## ***Boulder Commons***

Rocky Mountain Masonry Institute  
Bret Terry, Technical Director  
686 Mariposa Street  
Denver, Colorado 80204

Job Site Visit: September 13, 2017

Report Written: September 26, 2017

***Figure 1***

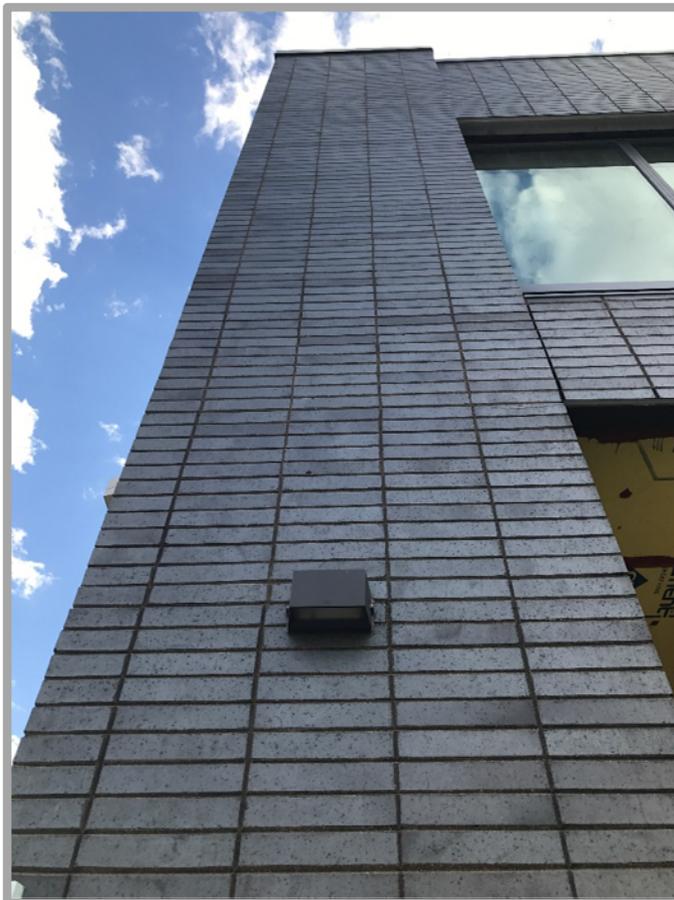
***Figure 1 shows an example of the material and typical workmanship of the stacked bond brickwork.***

Note: The mason contractor's bricklayers maintained 3/8-inch wide mortar joints throughout the brickwork and used a "V-shaped jointer in lieu of the round jointer. All mortar joints appear to be properly sized and tooled.

**Figure 2**

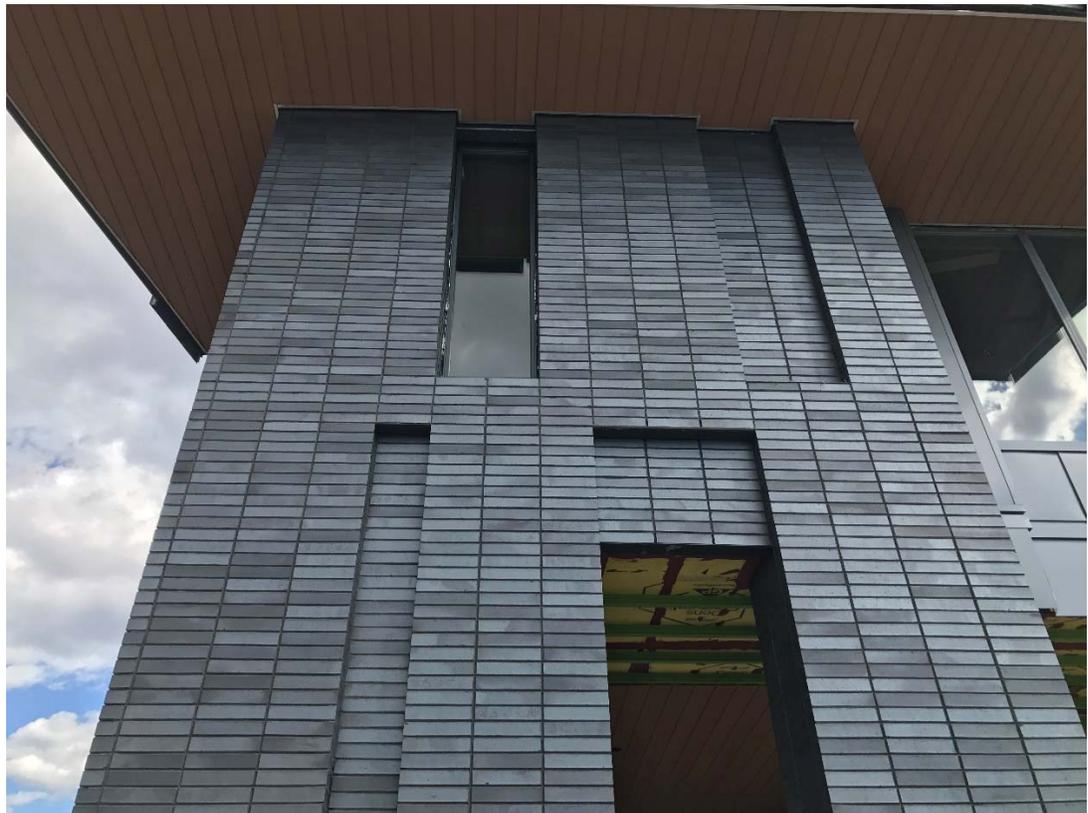
***Figure 2 is an area of the building where two different production runs of Endicott Brick Company's "Manganese Ironspot" brick was used without any apparent color range differences.***

There are slight "squiggles" in the head joints when sighted from below looking straight up the wall and are also detected when standing back from the building at a distance. However, these slight variations are well within industry tolerances and are extremely difficult to avoid in stacked-bond brick patterns, especially when using a dense brick as the kind manufactured by Endicott Brick Company. Endicott brick have a very low initial rate of absorption (IRA) are challenging for most masons to lay because the brick does not absorb much moisture from the mortar and the brick tend to "float" because it takes longer for the mortar to set.
